UNITED STATES  
NUCLEAR REGULATORY COMMISSION  
WASHINGTON, D. C. 20555

Enclosed is the first round of questions on the Mark III LOCA-related pool dynamic load criteria. Our review was based on the information contained in Appendix 3B, Rev. 0, of GESSAR-II and the reports referenced therein.

REQUEST FOR ADDITIONAL INFORMATION  
MARK III POOL DYNAMIC LOADS ISSUES -

Fig 1

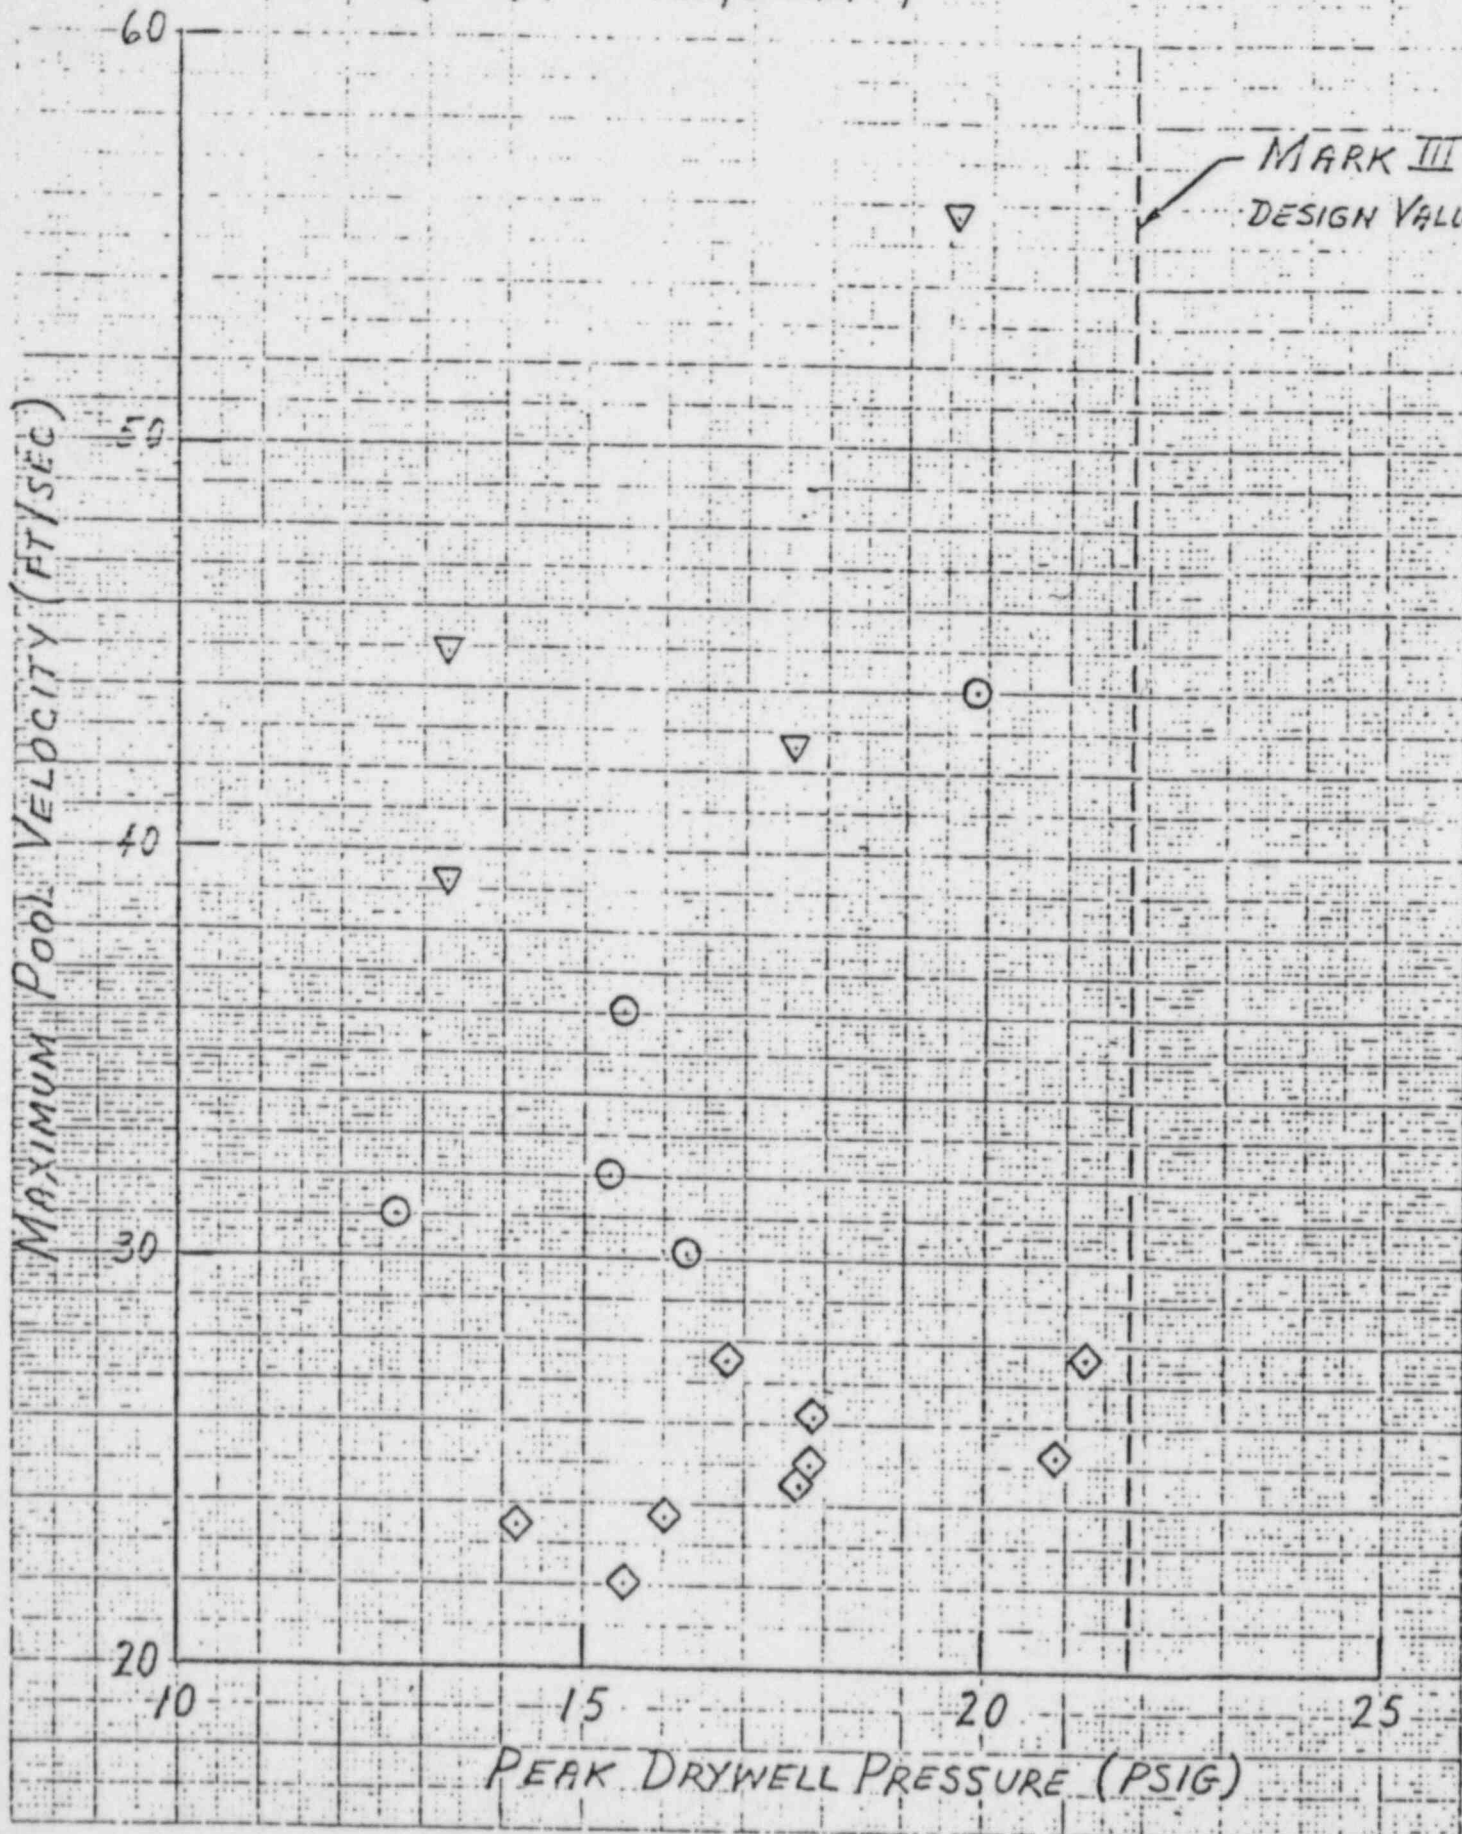
From MIT's Case 1, which corresponds to a "peak" drywell pressure of 29.4 psi, we get a scaled-up maximum pool speed of approximately 50-55 ft/s for all three systems. This happens to compare fairly well with the extrapolated 1/3-area scaled Mark III test results (see figure B).

The only point we want to make with these comparisons is that it is difficult to justify the direct use of GE's 1/3 area scale data for peak pool swell velocity. The MIT investigation shows that the full scale pool velocity may be considerably higher, although the magnitude of the difference depends on conditions that cannot be easily predicted (a single "coefficient" is not sufficient).

Fig 2

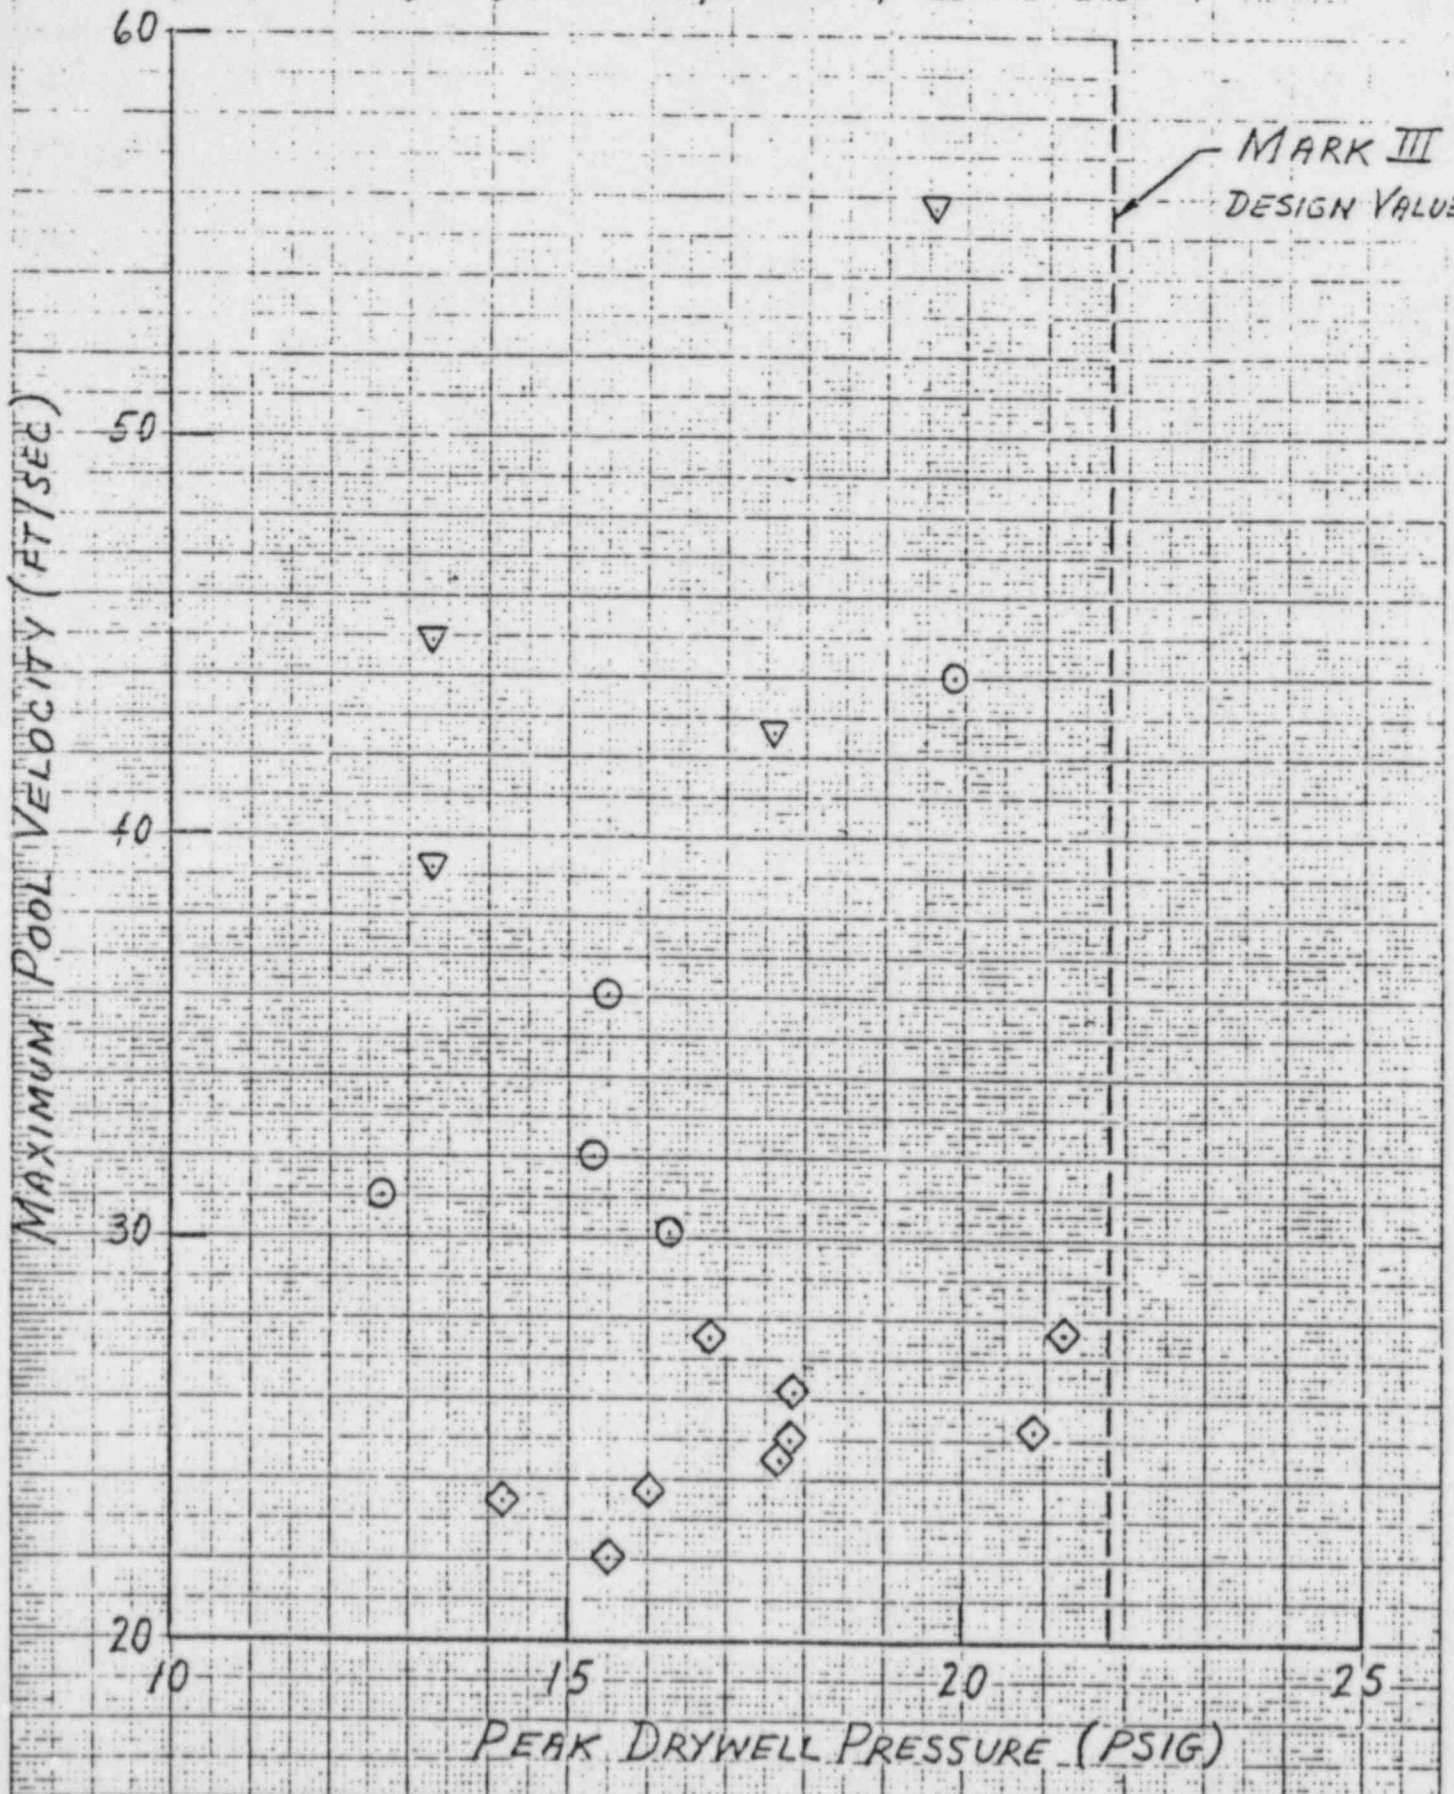
Figure 2 shows a summary of the 1/3 and 1/9 scale data points for maximum pool speed at 7.5 ft submergence, plotted against the peak drywell pressure. The Mark III design peak drywell pressure is 21.8 psig. We note that:

- (a) Air blowdowns in the 1/3-scale system gave consistently higher pool speeds (by about 10 ft/s) than steam blowdowns.
- (b) 1/3-scale steam blowdowns gave consistently higher (by 10-15 ft/s) pool speeds than 1/9-scale steam blowdowns.
- (c) Based on the 1/3-scale steam blowdown data, the most appropriate maximum pool speed corresponding to Mark III peak drywell pressure is about 45 ft/s.
- (d) If we were to try to extrapolate linearly from 1/9-scale and 1/3-scale to 1/1-scale to obtain a Mark III maximum pool swell at 7.5 ft submergence and with steam blowdown, we would get a figure in the neighborhood of 60 ft/s.

This is not necessarily a conservative figure, since (i) the data are based on distorted-geometry steam blowdowns, not air blowdowns, and (ii) the MIT experiments on distorted-geometry testing show that such extrapolations can be quite nonlinear.

Please provide your comments on the above discussion and provide additional justification for the design basis pool velocity of 40 fps.
